RotorSport UK Ltd

Service Bulletin

SB No.: 007 issue 1

Aircraft type & model (applicability)
RotorSport UK MT-03

View under the tail.

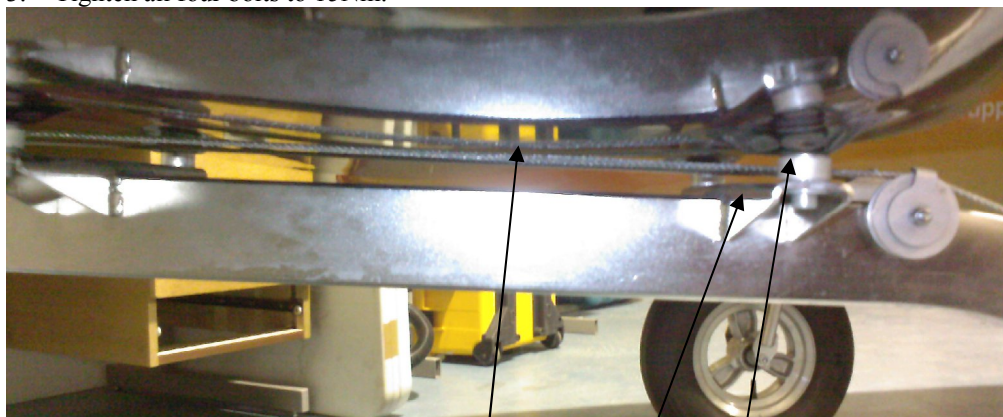
A factory manufacturing dimensional variance has been found on one of the UK fleet on the through bolt hole in the keel for the rudder pulleys. This hole may on one side of the keel be a slot instead of a 5mm hole, used by the factory to allow pulley alignment with the keel. A slot is an acceptable rework by the factory, provided the pulley assembly is lined up correctly with the keel. However, vertical positional variance of the bolt may lead either to the cable rubbing on the underside of the tail or on the top of the front rudder mounting bracket. This service bulletin is to address that variance.

Check clearance of cable to tail and the bracket. Add washer between each spacer and tail/bracket if required

a) Increase tail height.

1. Loosen all four tail mounting bolts by several turns. Remove two left side bolts, add a 1.5mm washer between the each spacer and mounting bracket, and replace bolt with loctite 243 liberally spread on the threads of the bolt. Do not tighten yet.
2. Repeat on right side.
3. Tighten all four bolts to 15Nm.

See pictures below for how to check cable tension

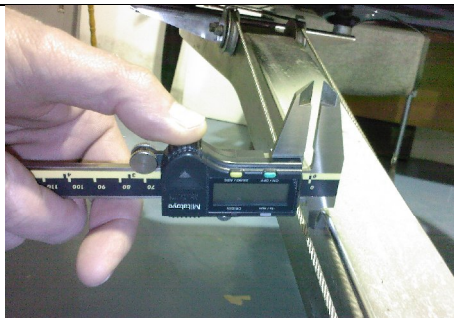
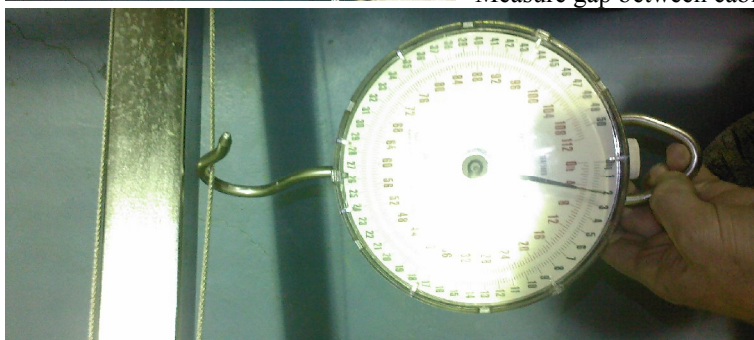
Measure gap between cable and tail boom mid way between pulleys.

Apply a tensile load of 2Kg, and re measure gap. Cable should move between 14 and 24mm. Adjust as required.
